- 7. Beaver Creek Alaska Subdivision 2020 Replat; KPB File 2021-006
Segesser Surveys / Freedom Indeed LLC
Location: Kenai Spur Road & Beaver Loop Road
City of Kenai**

ITEM 7 – BEAVER CREEK ALASKA SUBDIVISION 2020 REPLAT

KPB File No.	2021-006
Plat Committee Meeting:	May 23, 2022
Applicant / Owner:	Freedom Indeed LLC and Luke Saven LLC, all of Kasilof, Alaska
Surveyor:	John Segesser / Segesser Surveys
General Location:	Kenai Spur Highway and Beaver Loop Road, City of Kenai

STAFF REPORT

Beaver Creek Alaska Subdivision 2020 Replat

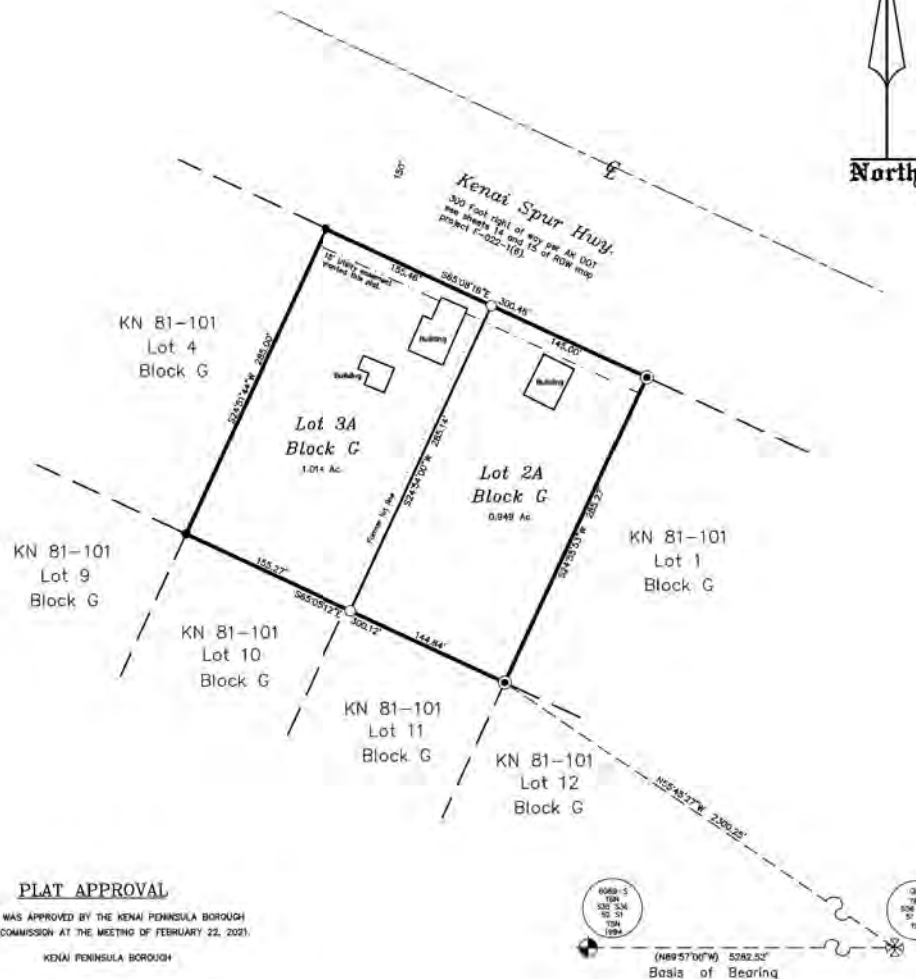
Staff Discussion: The Kenai Peninsula Borough Plat Committee heard and approved the preliminary plat at the February 22, 2021 meeting. A final was received for review on March 11, 2021. The mylar was received on April 13, 2021 for final review. The surveyor was notified on both occasions that the soils analysis report had not yet been submitted for review.

The lot line is moving approximately 5 feet between the parent lots but a wastewater review is not on file for the parent subdivision and the parent subdivision was not approved by AK DEC or KPB under chapter 20.40.

Approval will require a new plat note for the exception granted and a correction to the wastewater disposal note present on the plat. The mylar has been signed and will require reprinting and obtaining new signatures prior to recording.

Staff recommendation: place notes on the final plat indicating any exceptions granted by the Plat Committee with the meeting date and provide the correct Wastewater Disposal note.

- GRANT THE EXCPETION REQUESTED TO THE ALL READY APPROVED PRELIMINARY PLAT, AND
- COMPLIANCE WITH KPB 20.25.070 (FORM AND CONTENTS), KPB 20.25.080 (PETITION REQUIRED), KPB 20.30 (DESIGN REQUIREMENTS); AND KPB 20.40 (WASTEWATER DISPOSAL), AND
- COMPLIANCE WITH KPB 20.60 TO ENSURE ADMINISTRATIVE APPROVAL OF THE FINAL PLAT.
